Addendum 128 – UN Regulation No. 129

Revision 4 - Amendment 9

Supplement 9 to the 03 series of amendments – Date of entry into force: 5 January 2024

Uniform provisions concerning the approval of Enhanced Child Restraint Systems used on board of motor vehicles (ECRS)

Figure 4
Arrangement for Testing a Forward-Facing Device

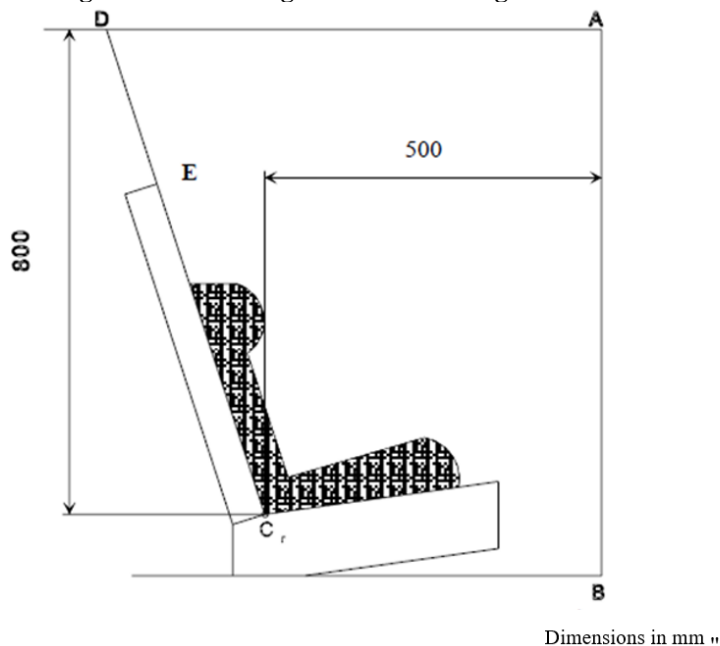
Paragraph 6.6.4.1.1., amend to read:

"6.6.4.1.1. Forward-facing Enhanced Child Restraint Systems

Integral Enhanced Child Restraints: No part of the head of the dummy shall pass beyond the planes BA, DA and DE as defined in Figure 4 below:

- (a) The value in relation to the BA plane is 500 mm; and
- (b) The value in relation to the DA plane is 800 mm, except when testing with the Q3 or Q6 dummy where the value is 840 mm; and
- (c) However, the head of the dummy may pass beyond the DE plane, if the head pad or the backrest part of the child restraint structure, which is behind the head of the dummy, at the point the head, passes the DE plane; and
- (d) In case of dummy contact with a rigid part of the test bench in the rebound phase, the head acceleration criterion during that contact shall not be considered.

Non-integral booster seat: No part of the head of the dummy shall pass beyond the planes BA and DA as defined in Figure 4 below.

When testing with the Q3 or Q6 dummy, the following applies:

The value in relation to the DA plane is 840 mm.

When testing the Q10 dummy, the following apply:

- (a) The value in relation to the BA plane is 550 mm; and
- (b) The value in relation to the DA plane is 840 mm; and
- (c) The rebound phase is not considered for the assessment of the plane DA.

Non-integral booster cushion: No part of the head of the dummy shall pass beyond the planes BA and DA as defined in Figure 4 below.

When testing with the Q6 dummy, the following applies:

The value in relation to the DA plane is 840 mm.

When testing using Q10 dummy the following apply:

- (a) The value in relation to the BA plane is 550 mm; and
- (b) The value in relation to the DA plane is 840 mm; and
- (c) The rebound phase is not considered for the assessment of the plane DA; and
- (d) In case of dummy contact with a rigid part of the test bench in the rebound phase, the head acceleration criterion during that contact shall not be considered.

6.6.4.4.1.1.1. Where a test is conducted in accordance with paragraph 6.6.4.1.6.1.1. or paragraph 6.6.4.1.6.1.2. or paragraph 6.6.4.1.8.2. above, a tolerance of +10 per cent shall be applicable to the head excursion value distance between the Cr point and plane AB.

"Figure 2

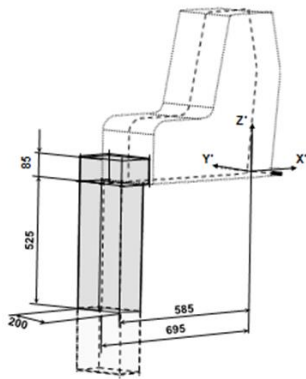
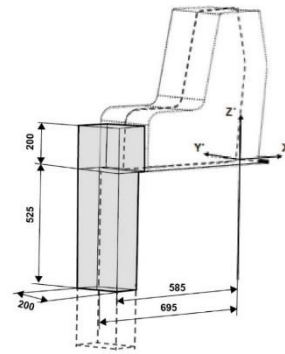
Annex 19., Figure 2, amend to read:

3D view of the support leg dimension assessment volume

Forward-facing ECRS

Rearward-facing ECRS
